Subject: Emergency Plan Document Revision Implemented June 26, 2019

ATTACHMENT 3
10CFR50.54(q) SUMMARY ANALYSIS REPORT
Page 1 of 2
Revision 0

50.54Q Title: Emergency Plan Section 3, Rev. 30, Emergency Organization

**EMERGENCY PLAN DOCUMENT REVISIONS
IMPLEMENTED June 26, 2019**

STATION RESPONSE WITH EXTERNAL INTERFACE
(FIGURE 3-2)
PAGE 1 OF 2

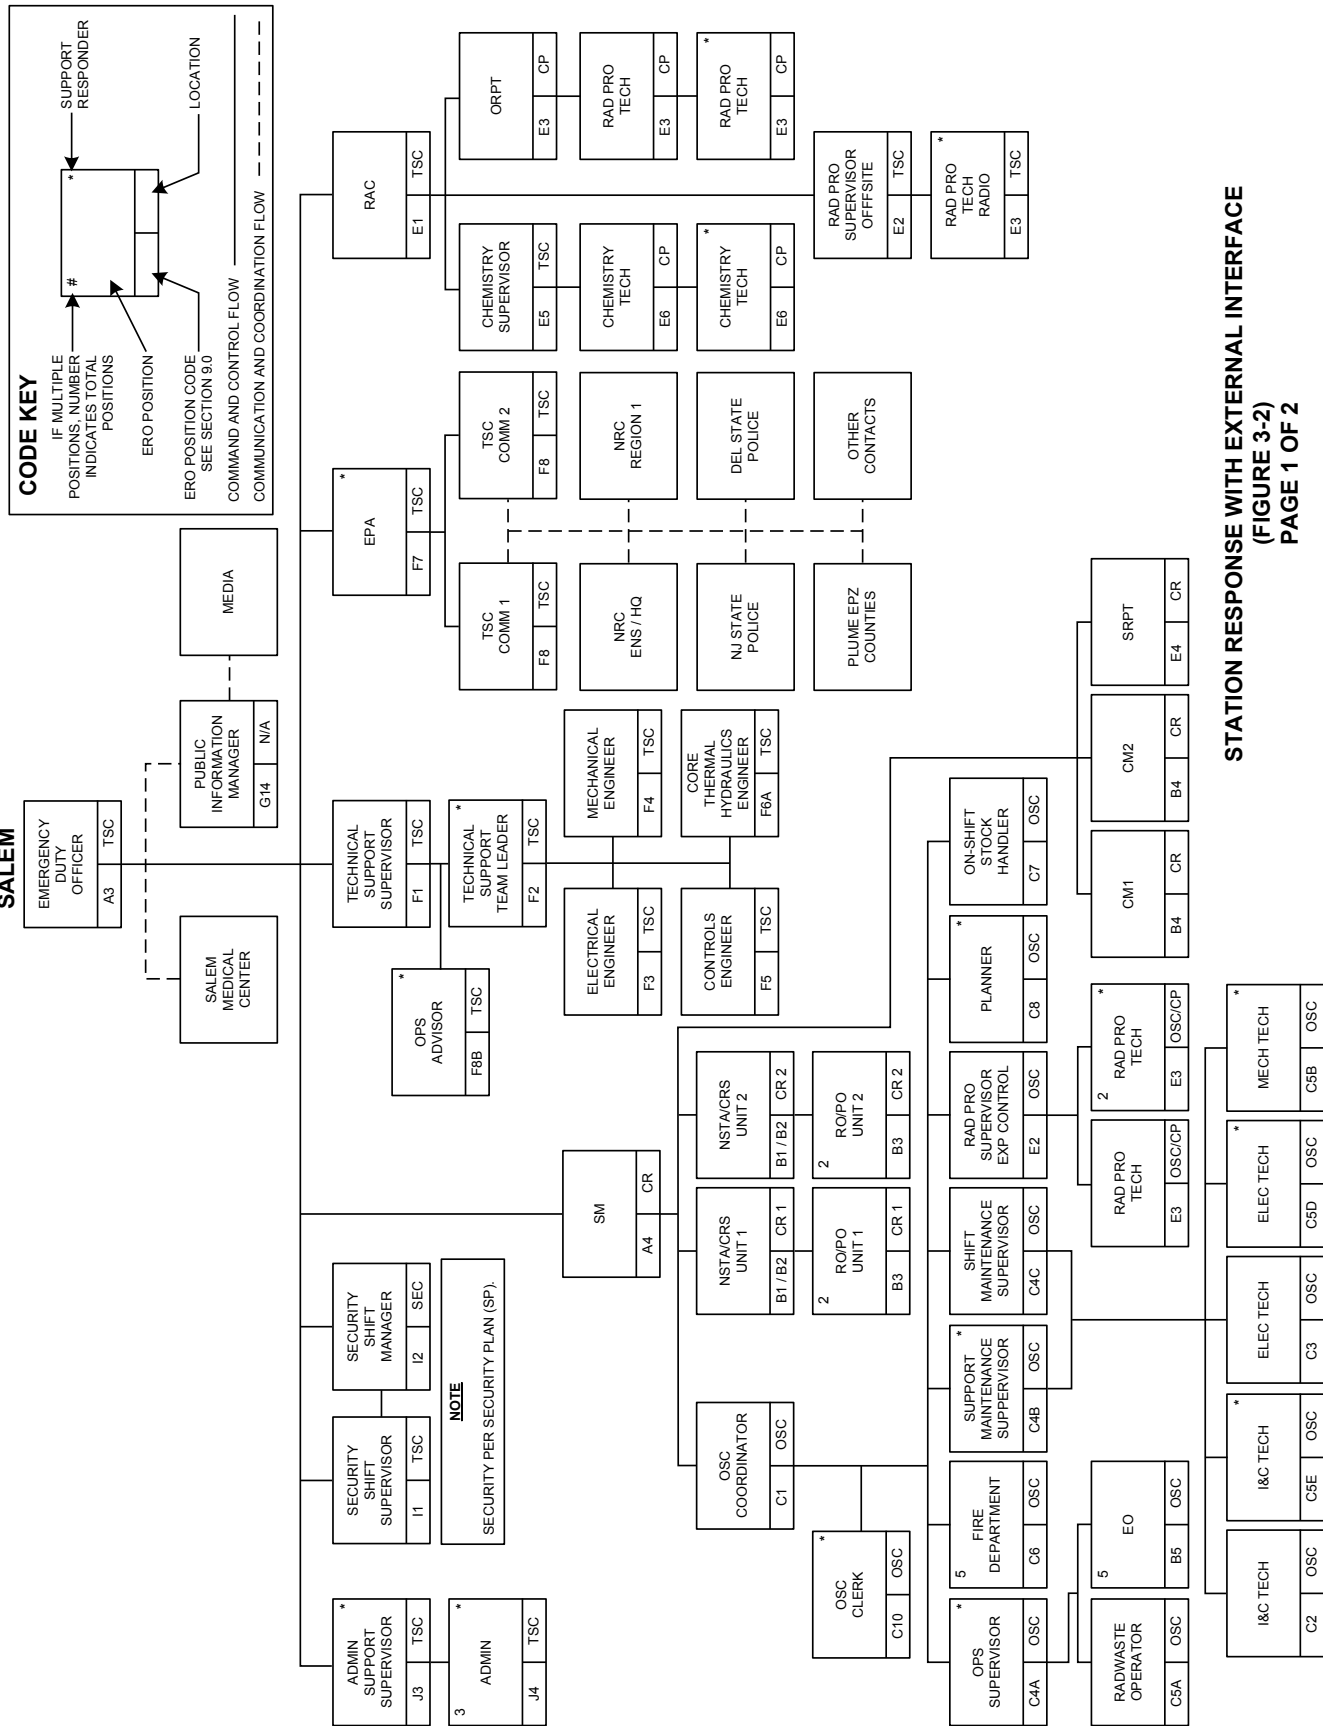
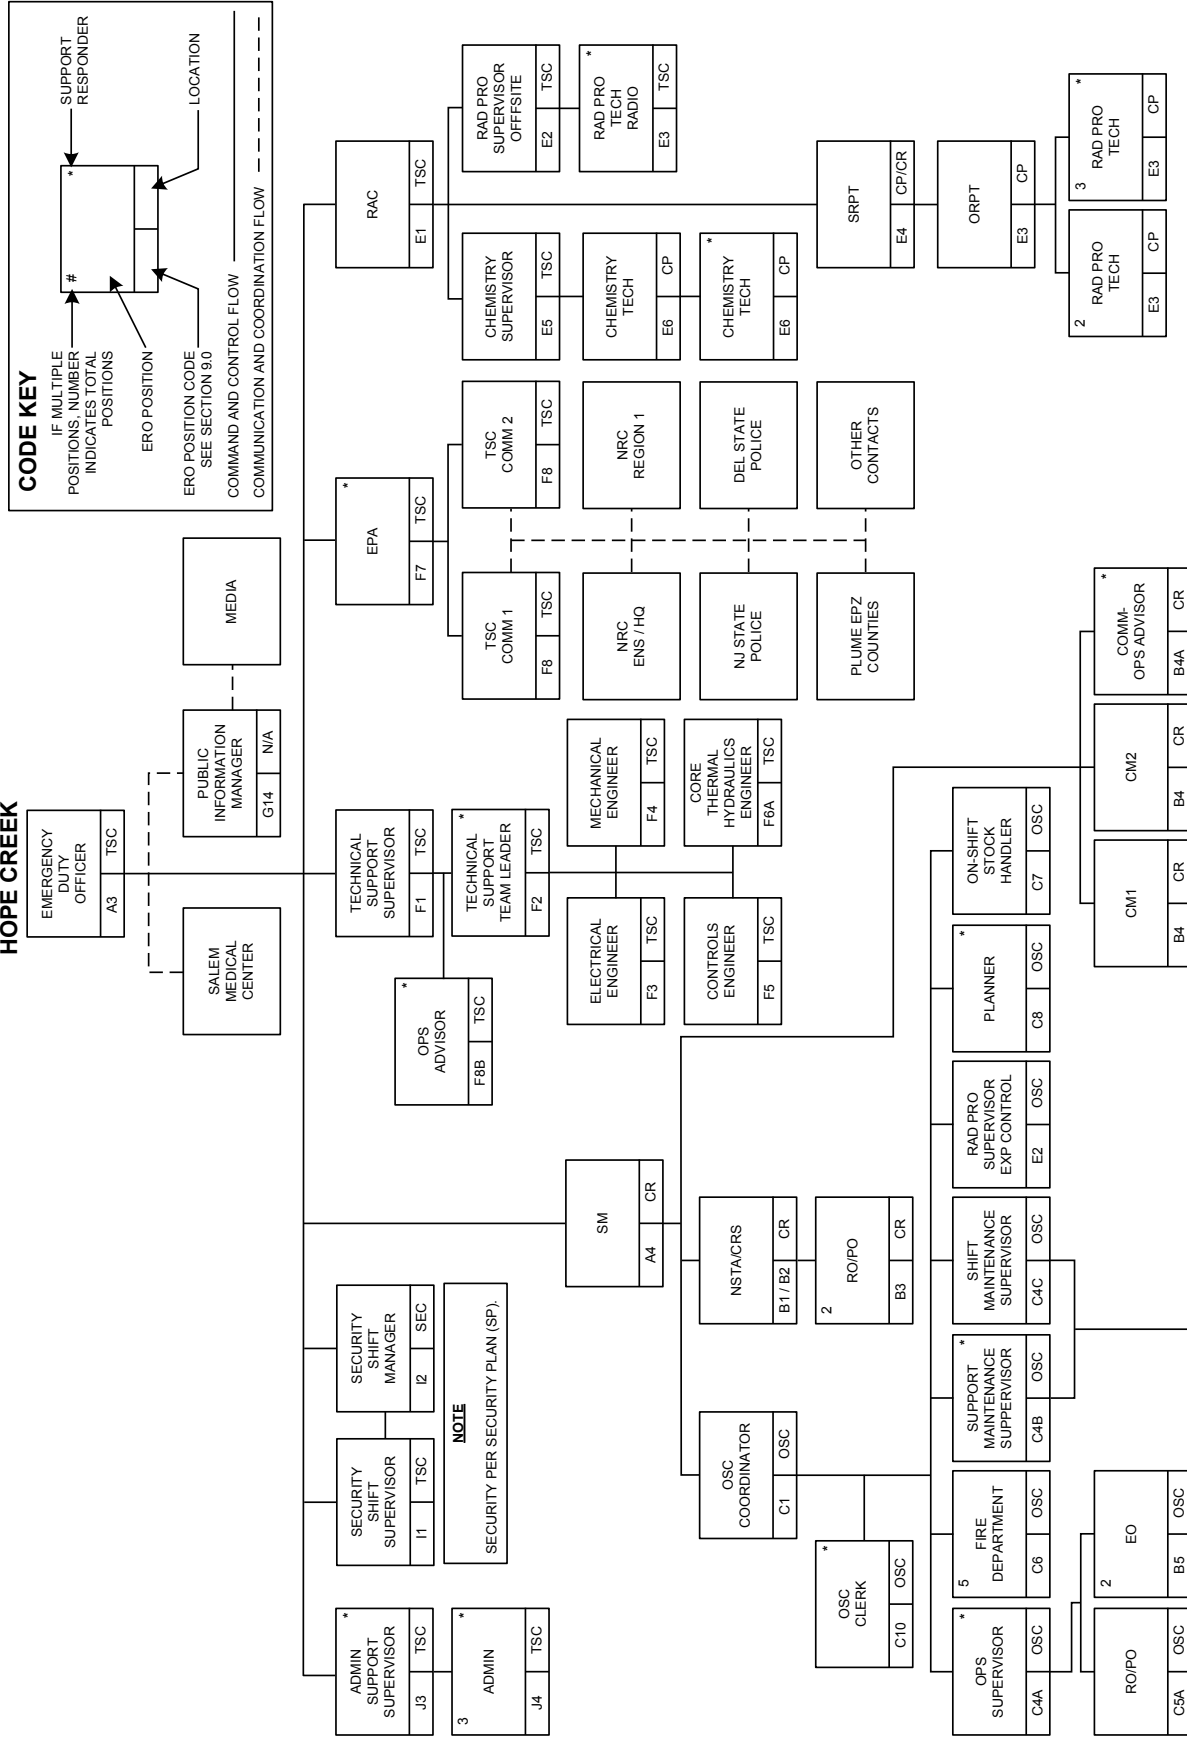
- Revised the following due to security organization changes – step 2.6, step 9.9 position titles and descriptions for positions I.1 and I.2, figure 3-2 position boxes for I.1 and I.2

- Figures 3-1, 3-2, 3-3, and 3-4 – updated code key boxes
- Figure 3-1 and 3-2 – deleted RMC box, changed “Salem Hospital” to “Salem Medical Center”
 - Hospital update is per change to EPlan section 13, evaluated under 50.54(q) 2019-28

- Figure 3-1 – added Note 2 to the HC OSC Coordinator box. Note was inadvertently omitted in Rev. 25
- Figure 3-2 – for readability, split Salem and Hope Creek into 2 pages, and deleted the notes that were associated with both stations appearing on the same page

- Figure 3-2 – updated various titles to match body of section 3
- Figure 3-3 – replaced box for “Material Control Supp” with “Purchasing” to reflect prior change

The removal of the RMC box from figures 3-1 and 3-2 is to rectify the Emergency Plan with a legacy issue. RMC was a rad service that has not been used for many years. RMC was credited as having a communication flow path to the Salem Hospital, the Shift Managers, and to the EDO. The current Emergency Plan provides for field teams from PSEG and from the states to monitor radiation releases. The deletion of the RMC box brings Emergency Plan section 3 up to date with the current configuration.
